# Access Compliance Report

## Public Rights-of-Way

### (Curb Ramps)

Intersection ID: N/A	Main Street: MONROE_RD	Cross Street: PRINCESS_ANN_DR	Location: W
ADA ID: 9F0A24E1026E	Ramp Type: PerpDiag	Initial Pass/Fail: Fail	Overall Compliance: No
Severity Score: 12.5			
Codes/Mitigation Info/Possible Solution		Field Measurements/Component Compliance

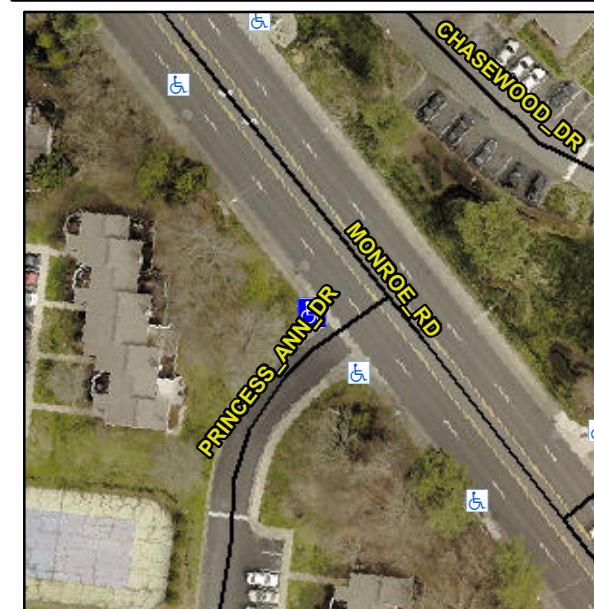
**Not Found, R304.2.2**

Compliance	Description	Data	Compliance	Description	Data
N/A	Ramp Length (in)	60.0	No	Ramp Slope (%)	8.7
Yes	Ramp Width (in)	48.0	Yes	Ramp XSlope (%)	0.8
N/A	Flare Type LT	N/A	N/A	Flare Type RT	N/A
N/A	Flare Slope LT (%)	N/A	N/A	Flare Slope RT (%)	N/A
N/A	Flare Traversable LT?	N/A	N/A	Flare Traversable RT?	N/A
N/A	Landing Length (in)	N/A	N/A	DWS Provided?	N/A
N/A	Landing Width (in)	N/A	N/A	DWS Contrast?	N/A
N/A	Landing Slope (%)	N/A	N/A	DWS Length (in)	N/A
N/A	Landing X Slope (%)	N/A	N/A	DWS Full Width?	N/A
N/A	Landing Curb? (Y/N)	N/A	N/A	DWS Offset (in)	N/A
N/A	Shared Landing?	N/A			
N/A	Gutter Ponding?	N/A	N/A	Gutter Slope (%)	N/A
N/A	Gutter Lip Ht (in)	N/A	N/A	Gutter X Slope (%)	N/A
N/A	Painted X Walk1?	No	N/A	Painted X Walk2?	No
	X Walk 1 Direction	To SE		X Walk 2 Direction	To NE
N/A	X Walk 1 Width (in)	N/A	N/A	X Walk 2 Width (in)	N/A
	X Walk 1 Slope (%)	3.9		X Walk 2 Slope (%)	1.5
	X Walk 1 X Slope (%)	1.8		X Walk 2 X Slope (%)	1.0

**Remove & Replace Curb Ramp With Two New Directional Ramps or Equivalent.**
